Subject: Beaver Creek Coal Company, CV Spur Hydrologic,
Vegetative and Wildlife Data

NOTICE OF AVAILABILITY
OF A TECHNICAL AND ENVIRONMENTAL ANALYSIS ON
THE MINING AND RECLAMATION PLAN FOR
BEAVER CREEK COAL COMPANY'S
C.V. SPUR COAL PROCESSING AND LOADOUT PLANT
CARBON COUNTY, UTAH

Technical and Environmental Assessment of C.V. Spur

Figure - 1
OSM Stability Analysis
Processing Waste Pile, C.V. Spur

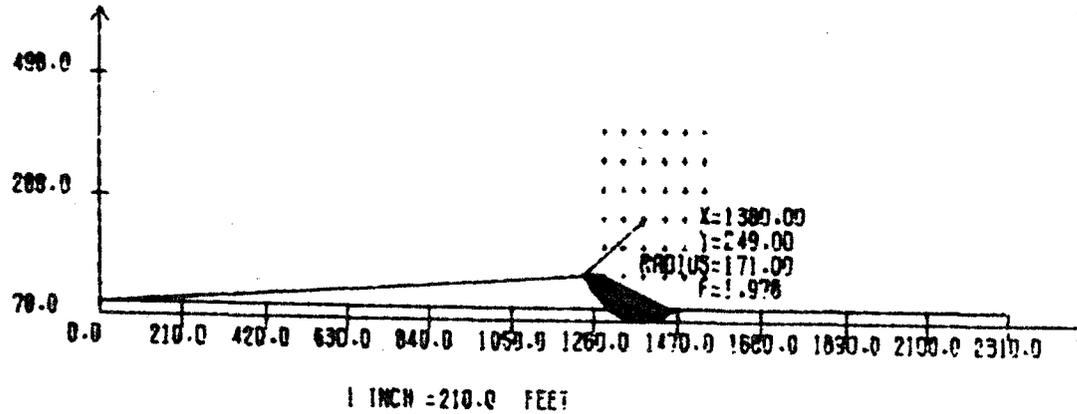
Long-term stability is analyzed by OSM, using the Slope II computer program and the Simplified Bishop Method. The OSM analysis is based on the most critical section of the waste bank and very conservative strength parameters are assumed for the processed waste and the foundation material. Provided the waste bank will be constructed to the performance standards as proposed, a minimum static factor of safety is calculated to be 1.98. Table 1 contains the strength parameter inputs and Figure 1 shows the graphical display of the computer solutions. Upon completion, the waste bank will be graded and contoured to establish surface drainage patterns. The site will be covered with at least eighteen inches of incombustible material in addition to six inches of topsoil and revegetated with specified seed mixture. Final configuration of the waste bank is shown in Exhibit 8, "Post-Mining Topography and Drainage." Applicant's proposal complies with 816.85.

Figure 1. Project Watershed Area

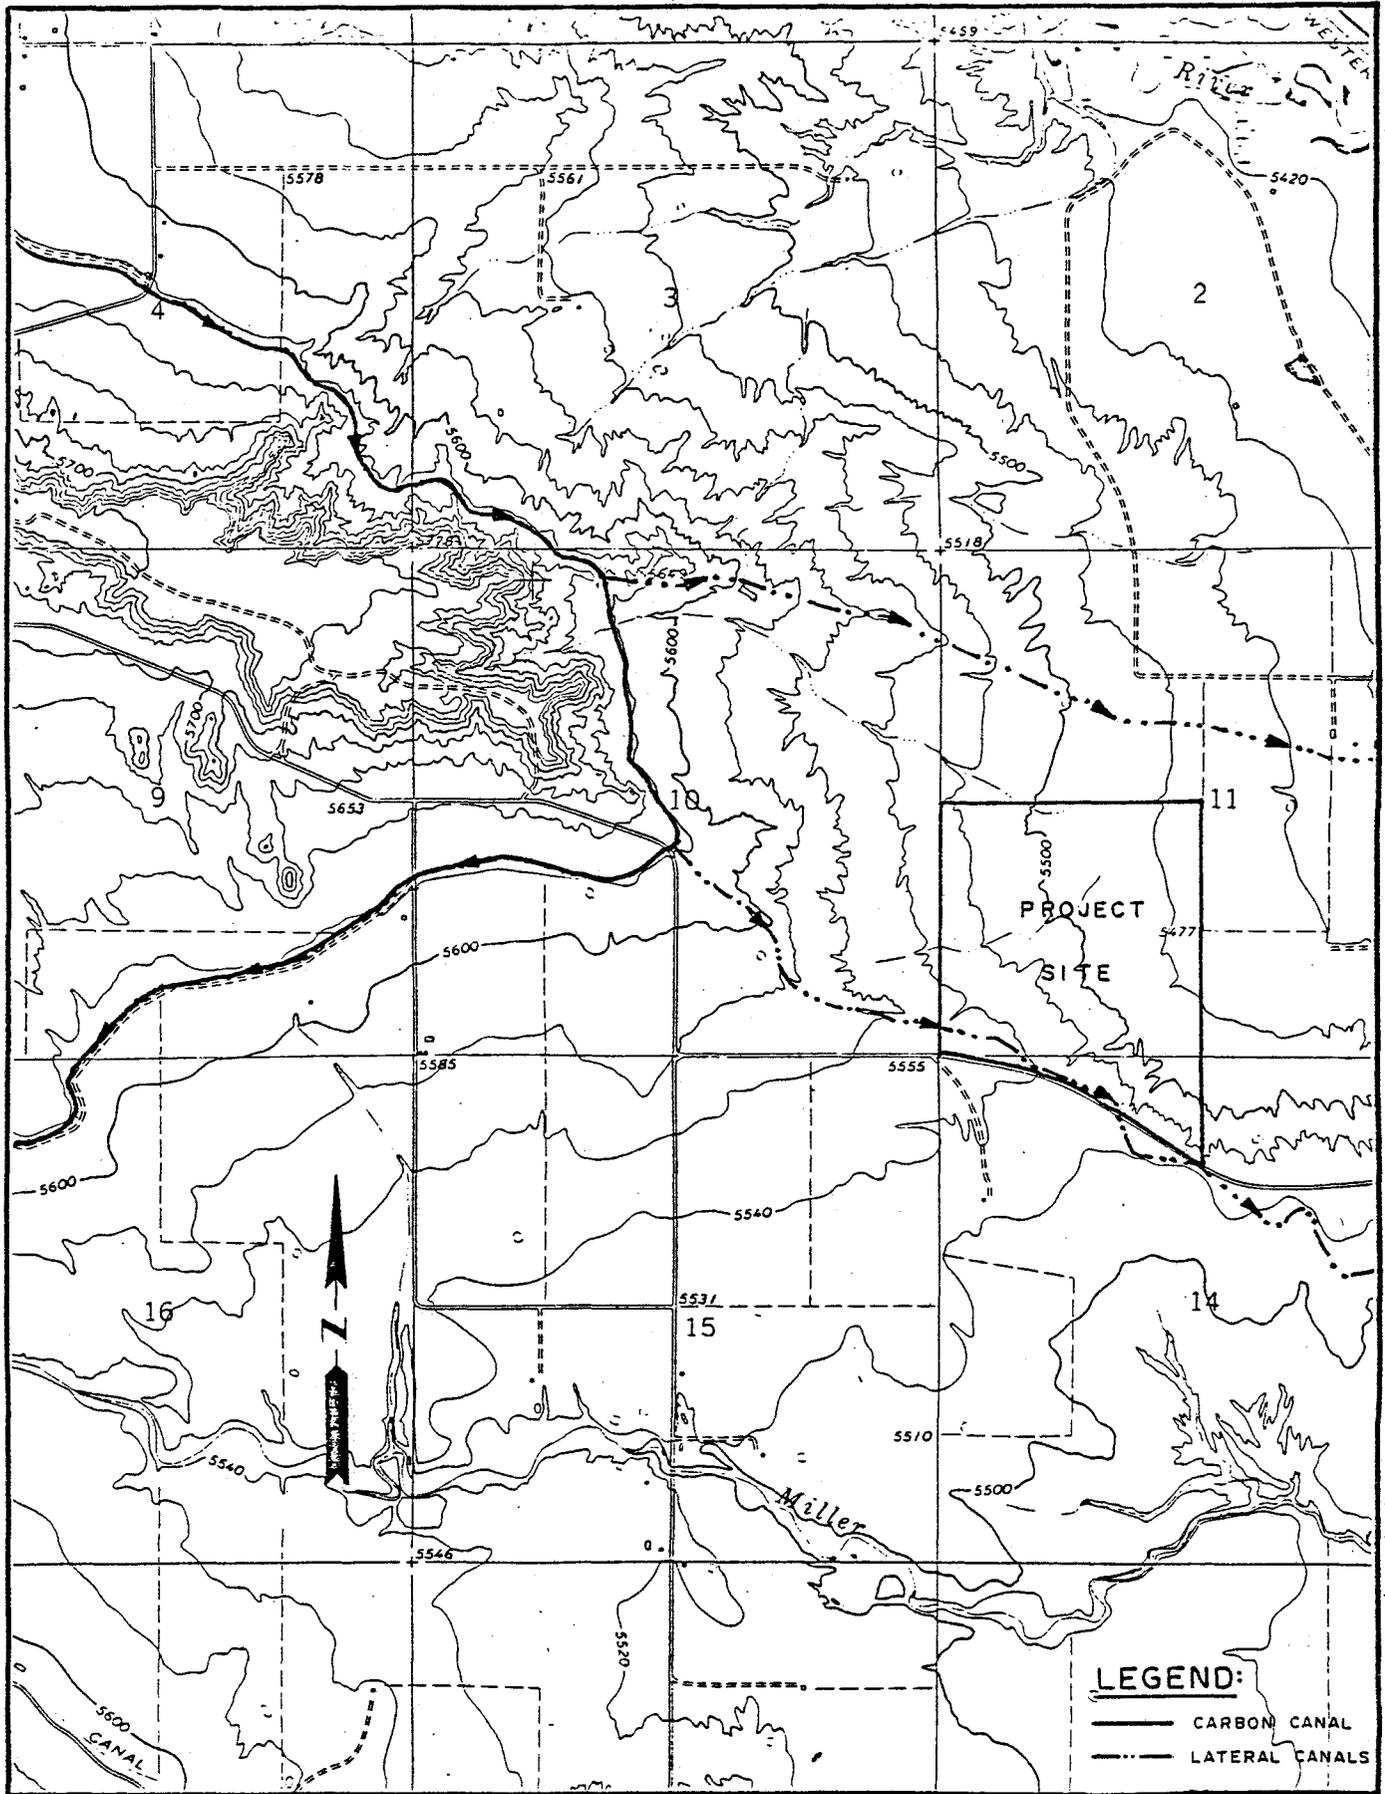
Beaver Creek Company's hydrologic study for C.V. Spur proposes that for the entire watershed (see Figure 1), the undisturbed areas (326 acres) should be assigned a curve number of 91 and disturbed areas (129 acres) should be assigned a curve number of 89. The study utilizes the Soil Conservation Service (SCS) method to determine the runoff volume for three categorized areas of the watershed. Subarea one, the largest area of the the three (296 acres), is estimated to yield a volume of 22.40 acre feet with a peak flow of about 35 cubic feet per second resulting from the 10 year, 24 hour storm event. Subarea two includes the entire disturbed area (129 acres) which yields 8.40 acre feet of runoff. Subarea three consists of only 30 acres of undisturbed land.

Figure 2. Ground Water Monitoring Locations

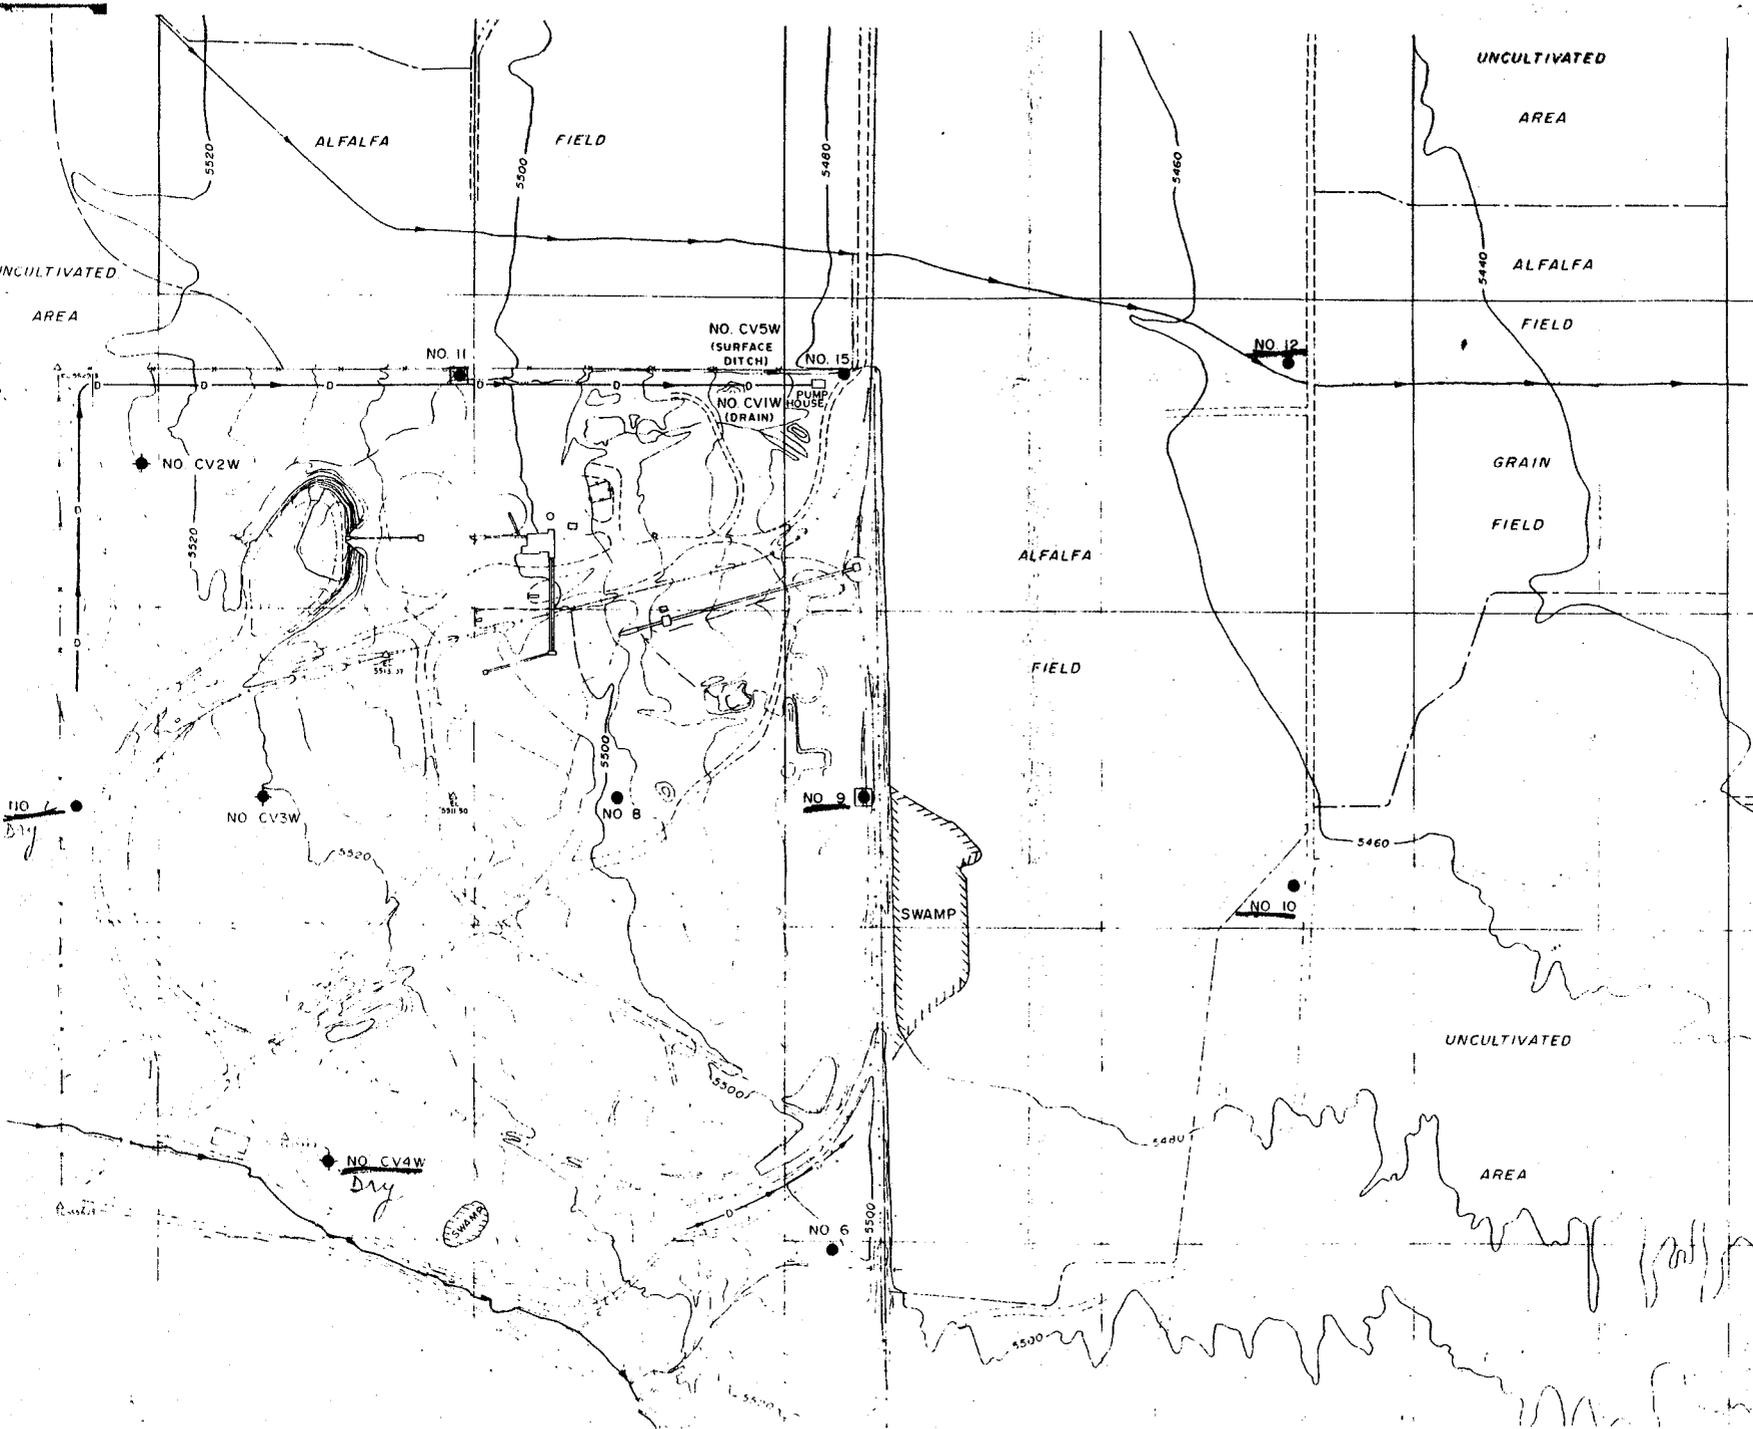
A swampy area east of the railroad tracks and near well No. 9 (see Figure 2), is thought to be the ground water discharge location of the C.V. Spur permit area. Ground water migrates down toward the Price River and if it does not evaporate first, it discharges into the river.

816.52(a) - Well numbers labeled on page 2-91, Figure 5, do not match the latest submission prepared by Rollins, Brown, and Gunnell, Inc., Figures 5 and 6. There is some resulting doubt as to what the C.V. Spur monitoring program will consist of and how the monitoring wells were selected.
